HOWIE POINT (NORTH 1)
FROM STA 0+00.00
TO STA 28+00.00

MEADOW RANCH II & III

GRADING & EROSION CONTROL PLAN COVER SHEET

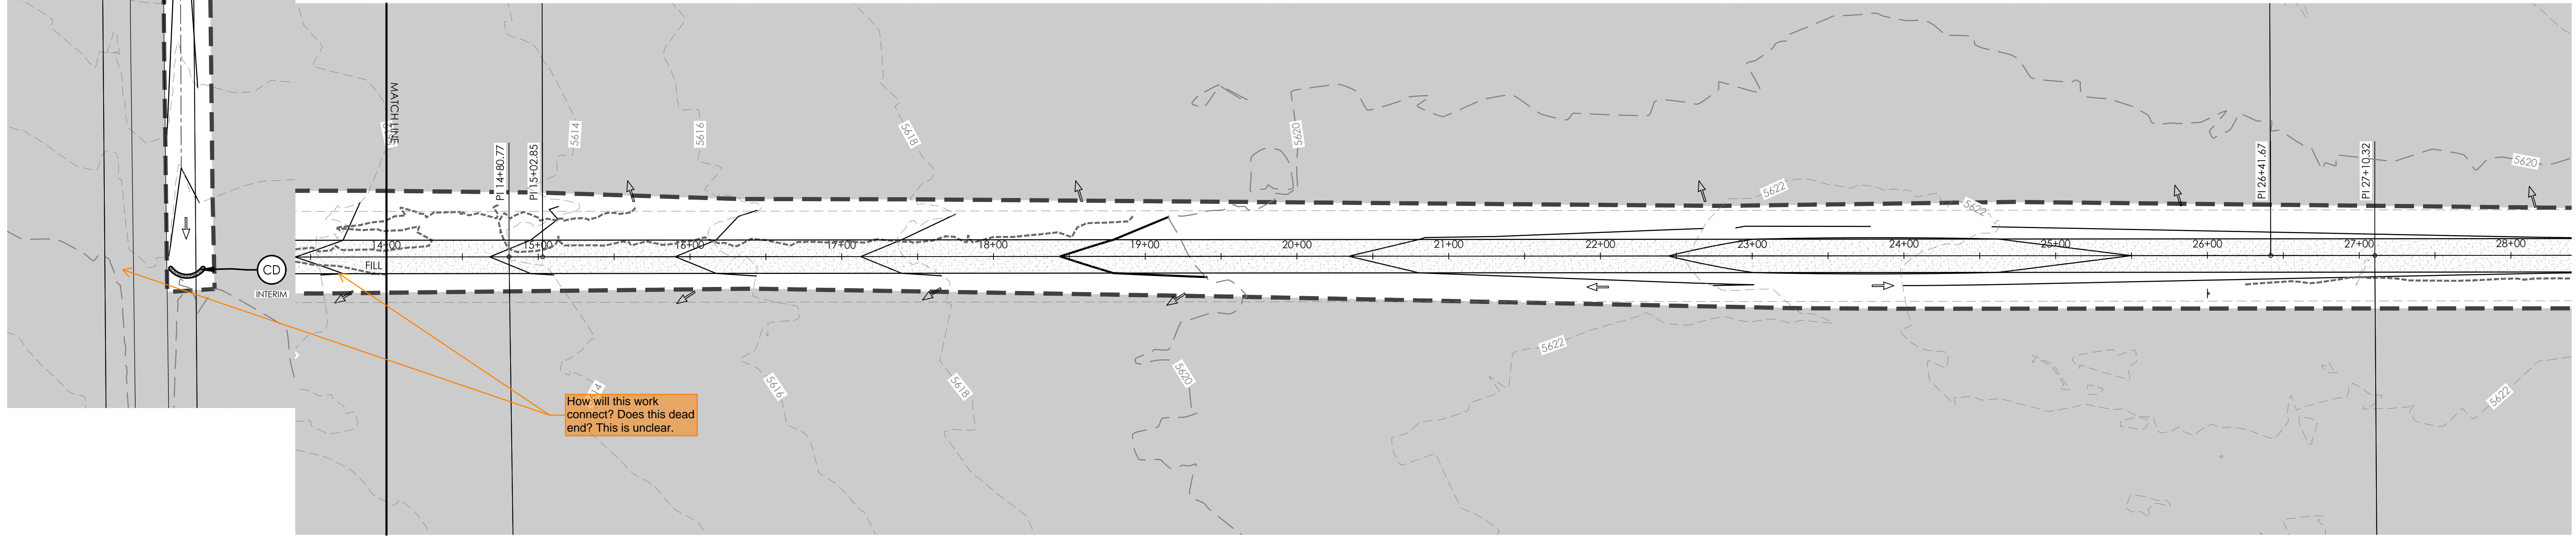
GEC Plans call for Straw Bale Barriers - provide or remove from SWMP.

All RPAs must be delineated and identified because they are permanent control measures treating the site. It must be identified that for the RPA areas, vegetation should have a uniform density of at least 80%. Topsoil suitability shall be demonstrated and steps for proper preparation of topsoil per recommendations in MHFD Detail T-0 Table RR-3 shall be incorporated into design. Provide detail for RPAs and UIA/RPA interface. See additional comments on the Drainage Report.

C1.2
SHEET **2** OF 12

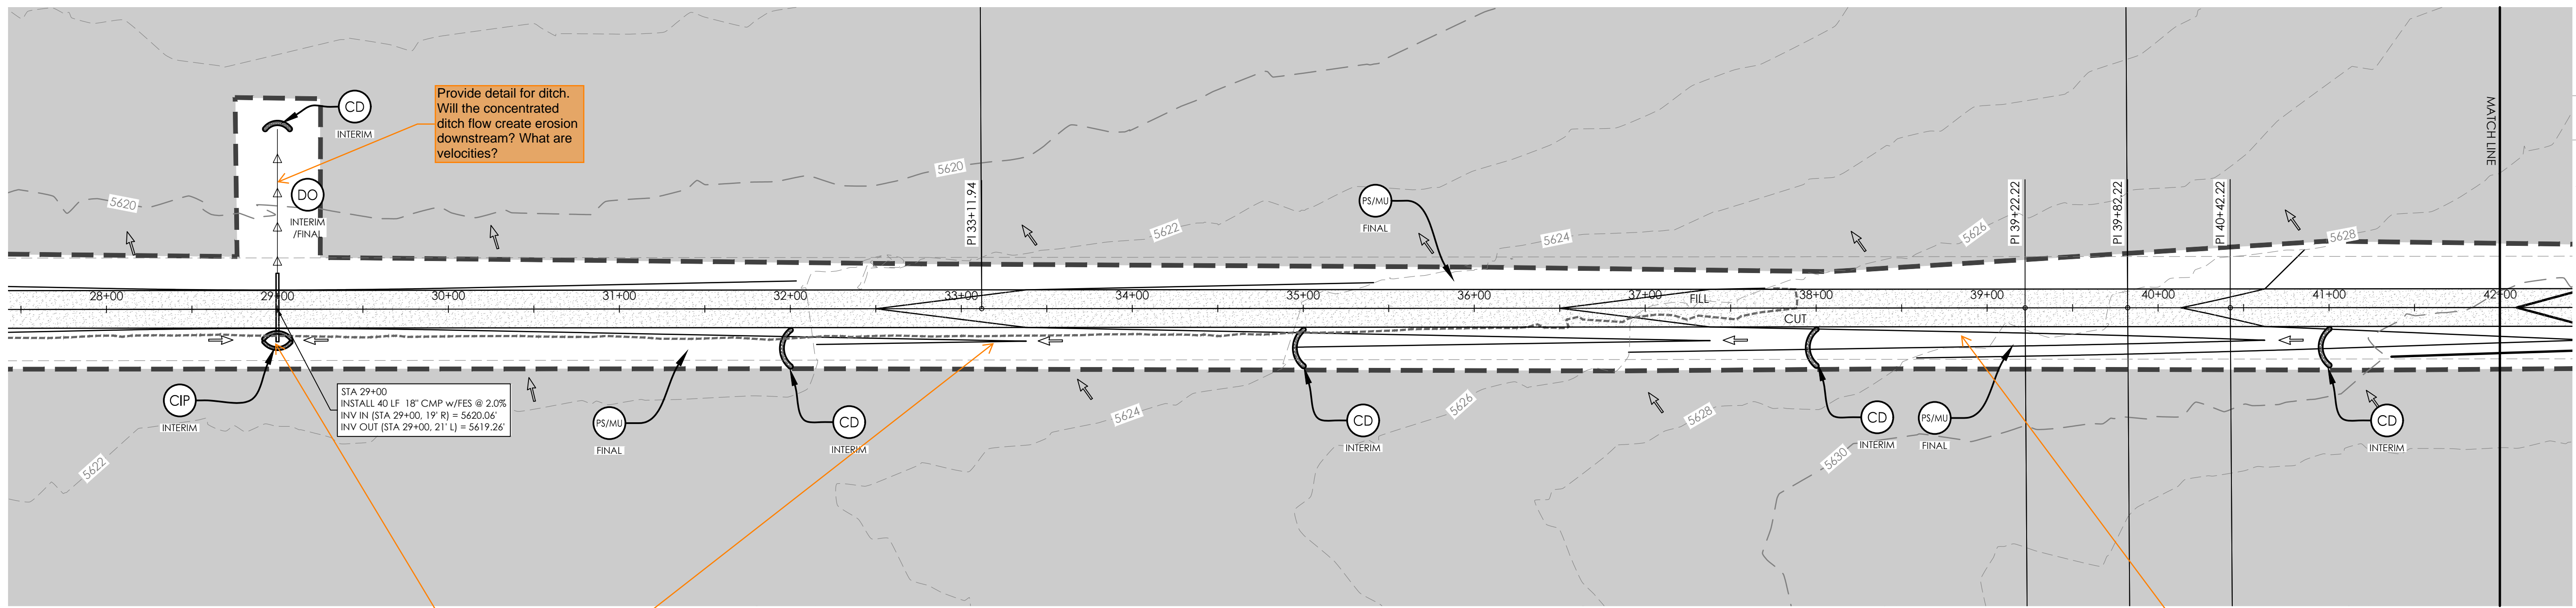
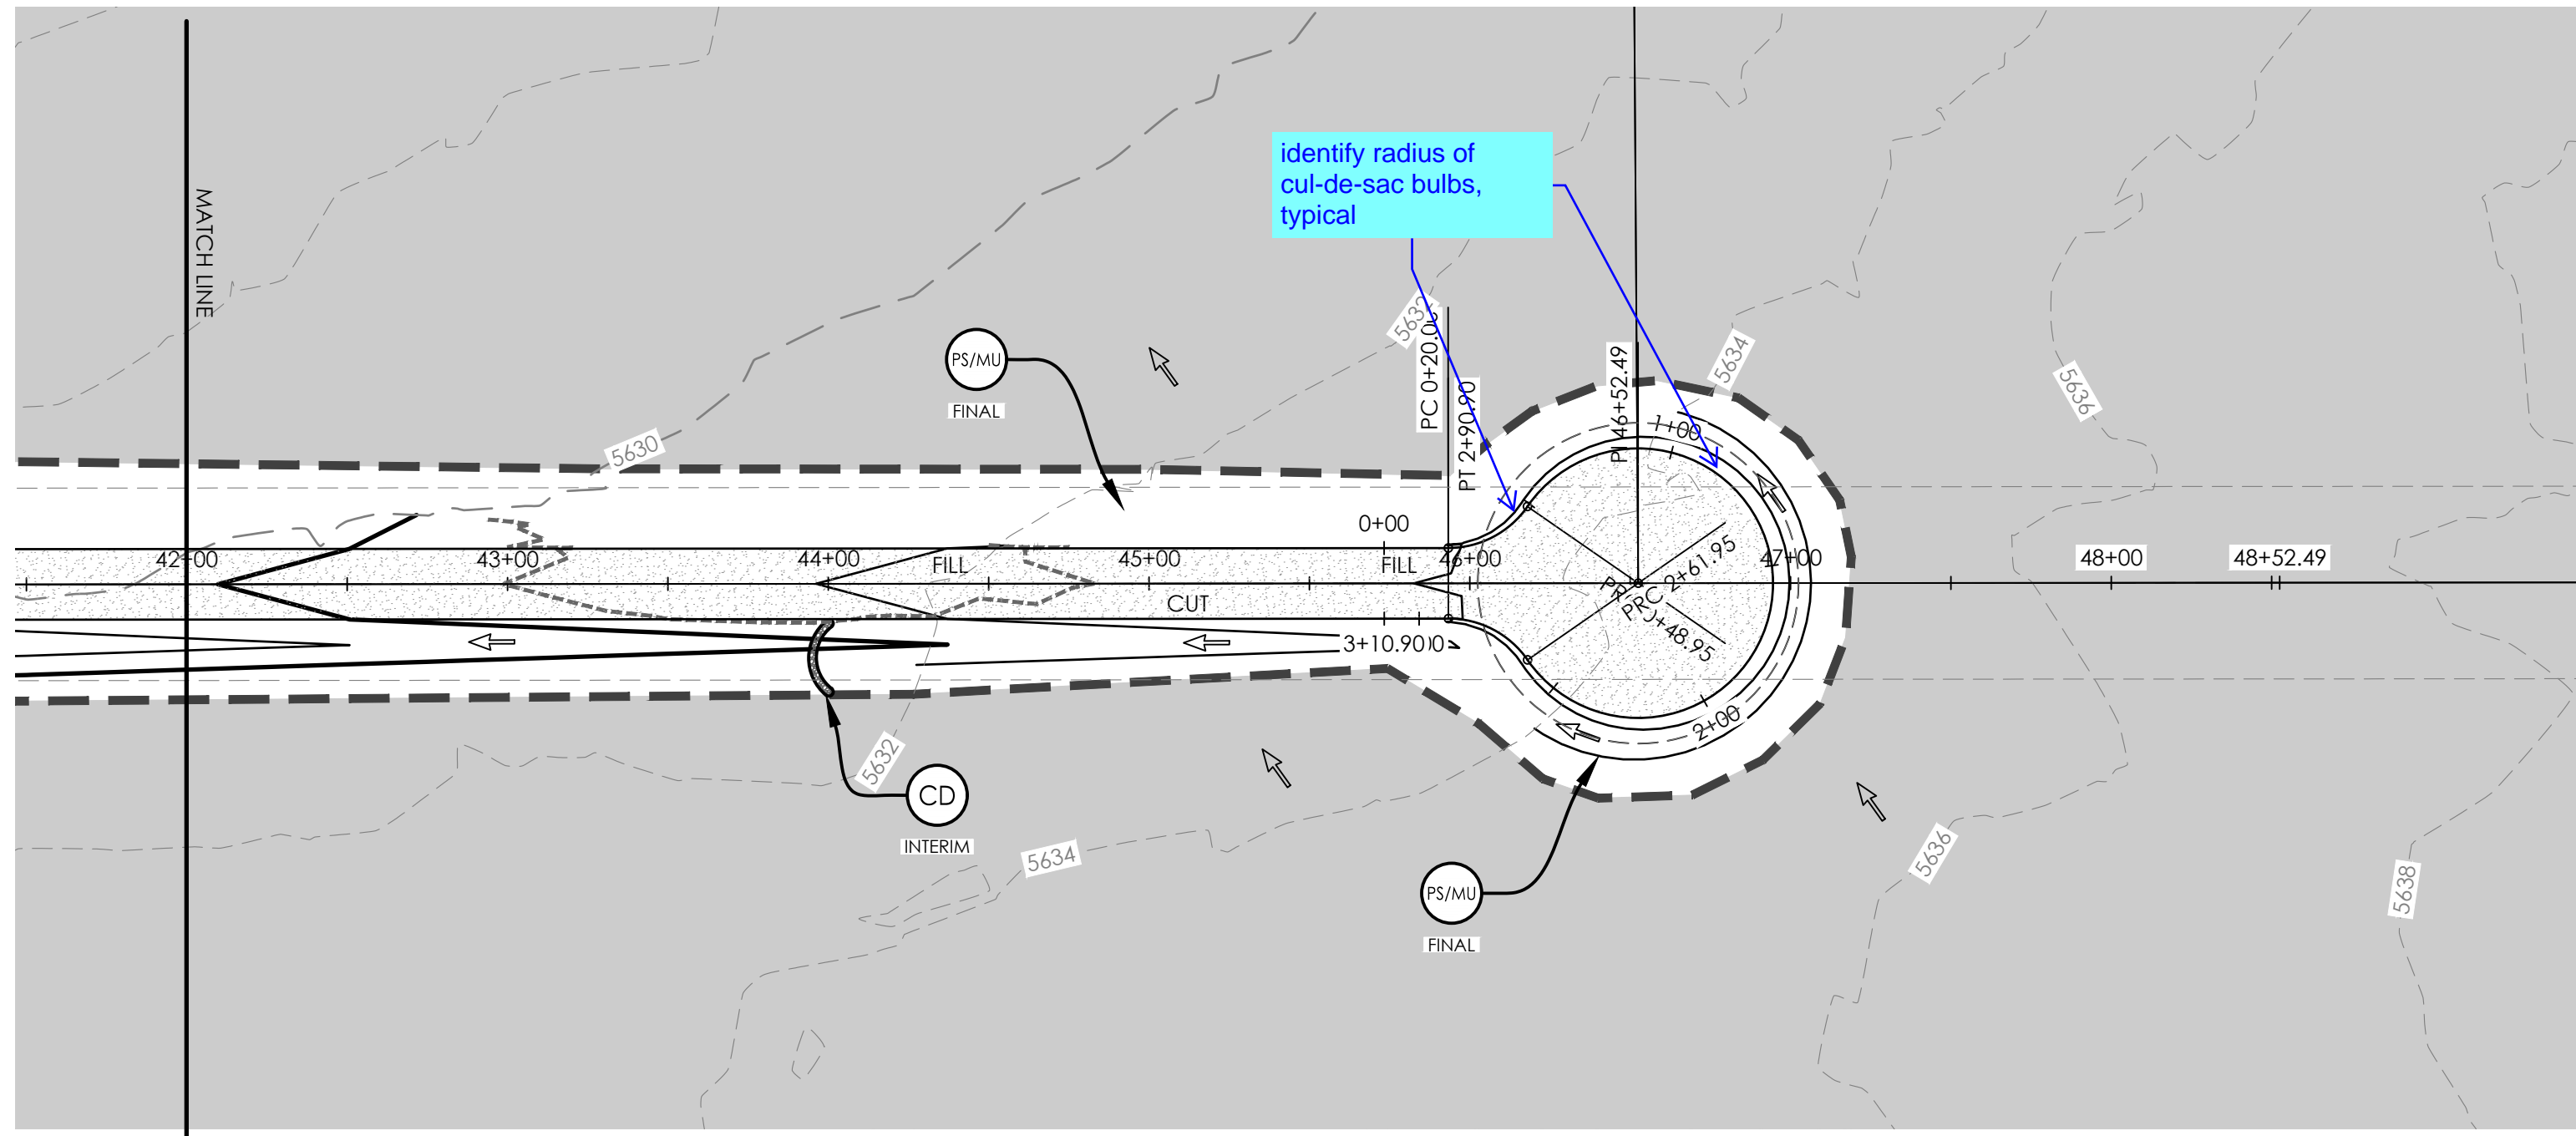
Provide detail for ditch. Will the concentrated ditch flow create erosion downstream? What are velocities?

Shouldn't there be more grading of the ditch to the culvert? It seems like this slope may be very shallow.

Provide detail/dimensions for proposed ditch.

identify radius of cul-de-sac bulbs, typical

C1.3

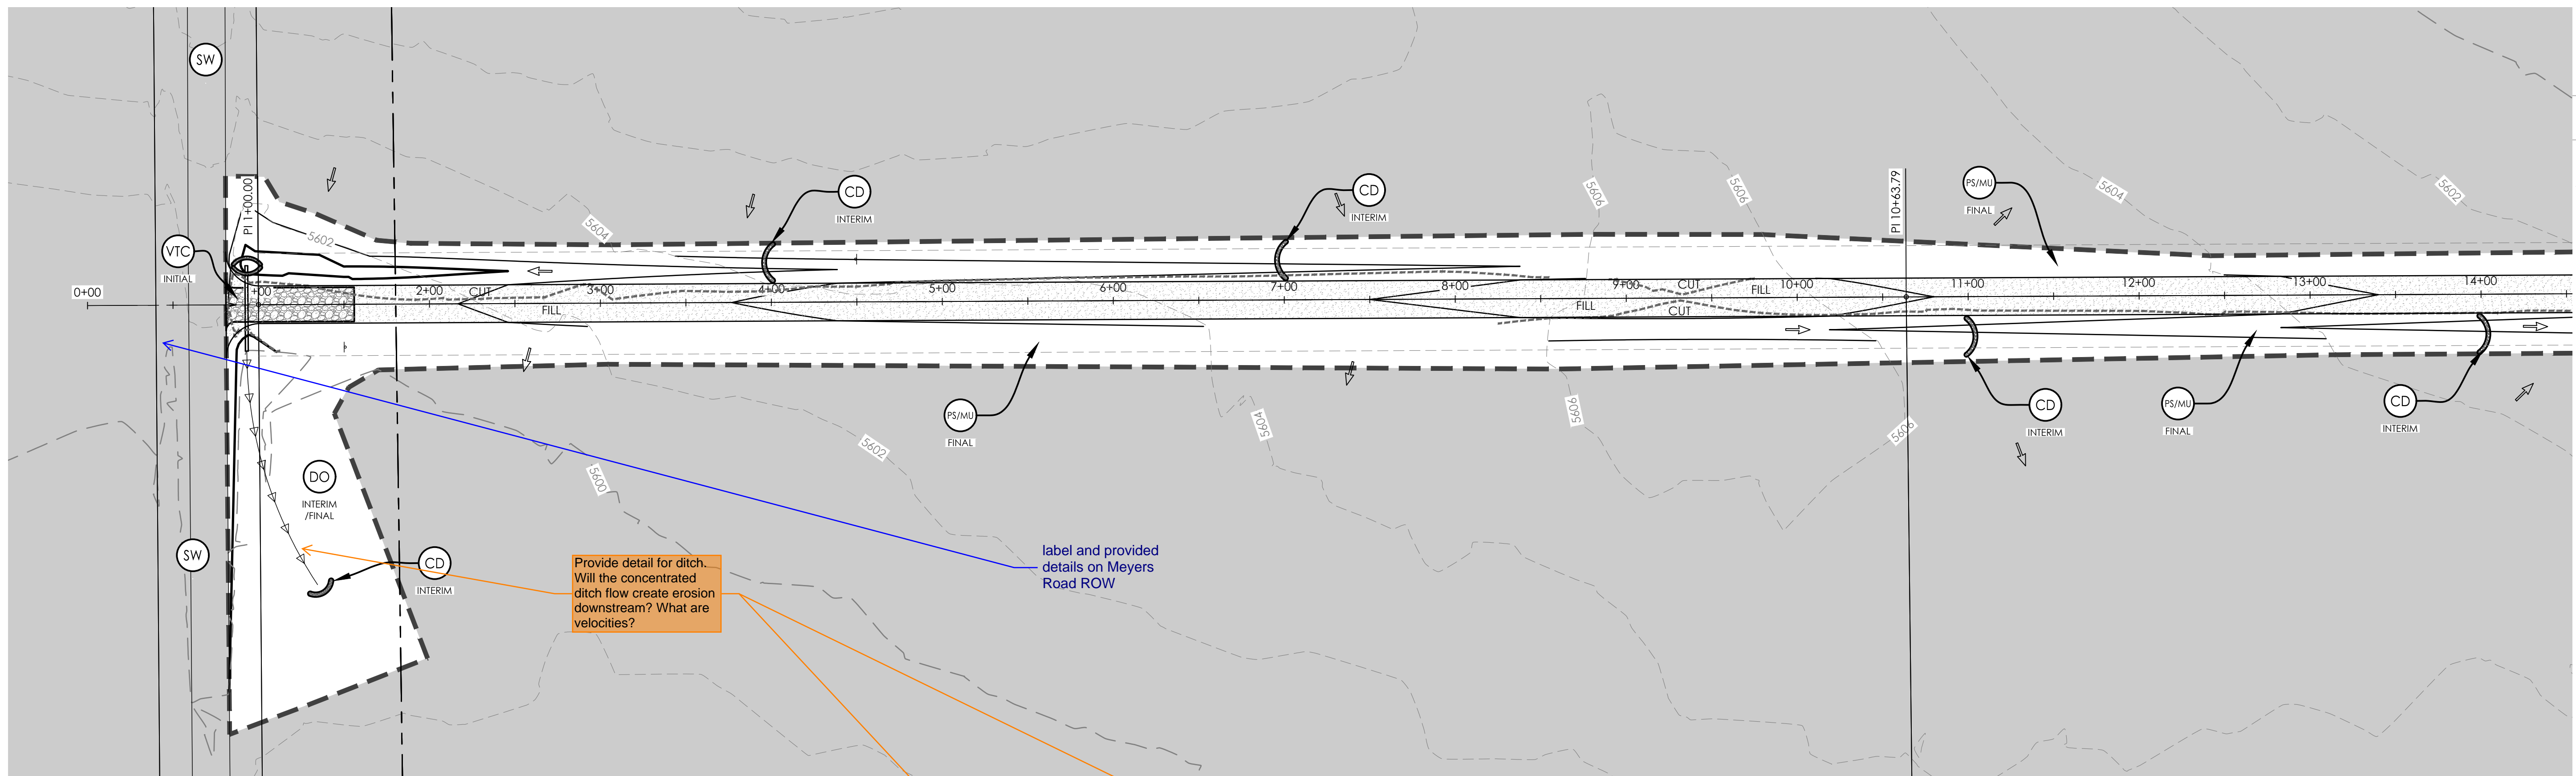
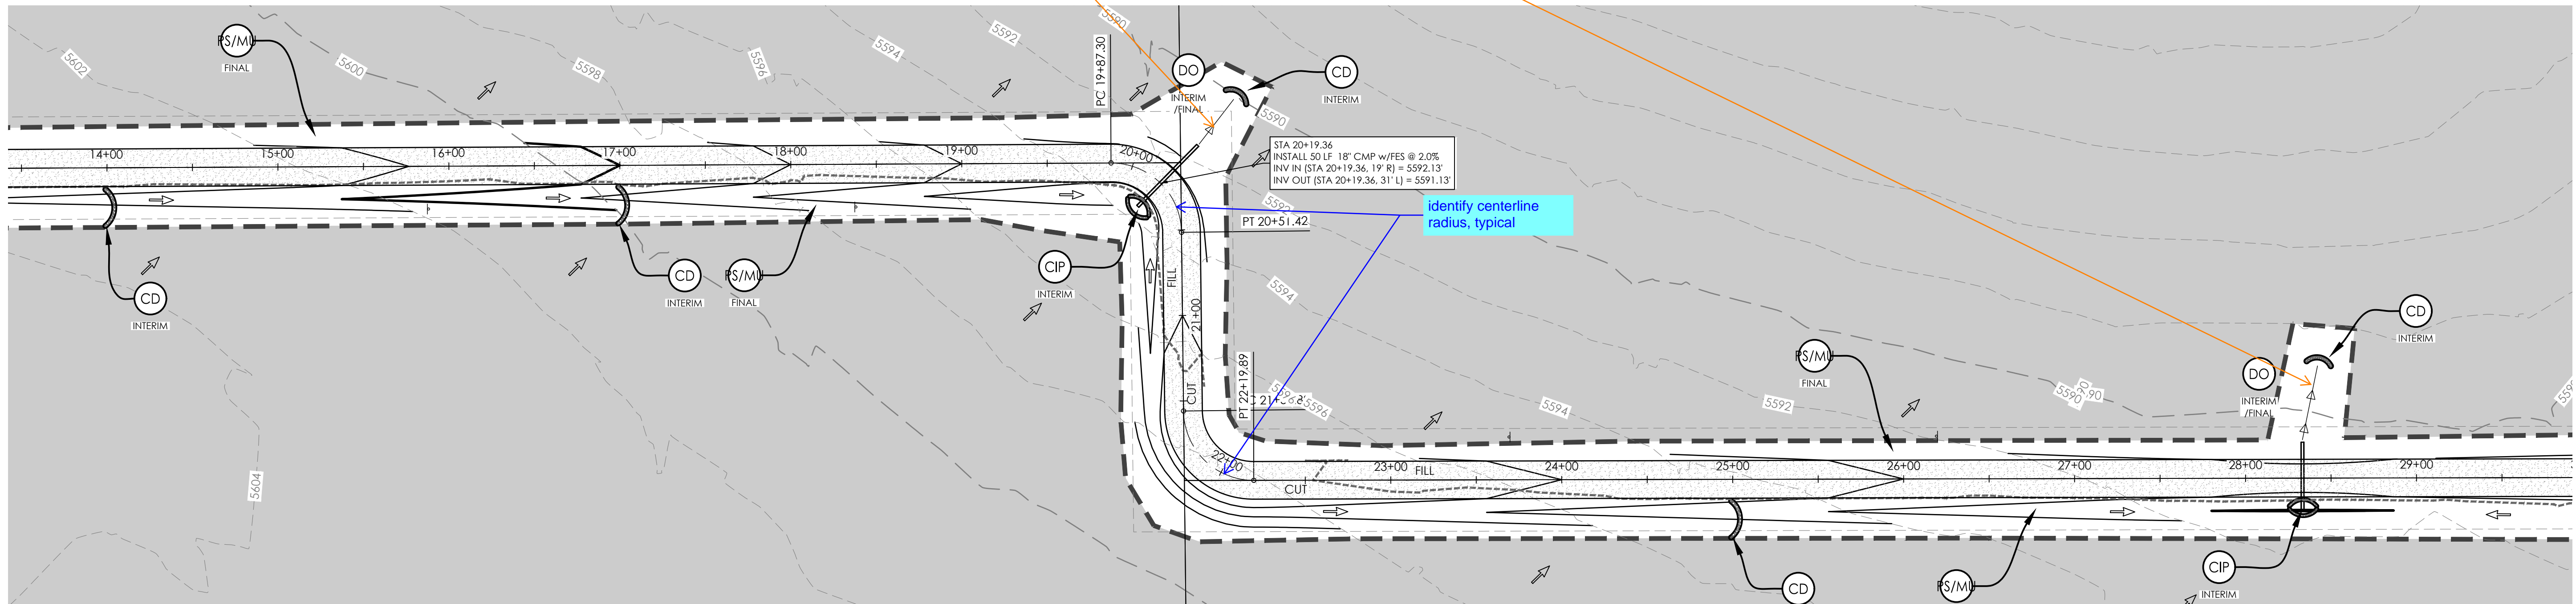
Provide detail for ditch. Will the concentrated ditch flow create erosion downstream? What are velocities?
label and provided details on Meyers Road ROW

identify centerline radius, typical
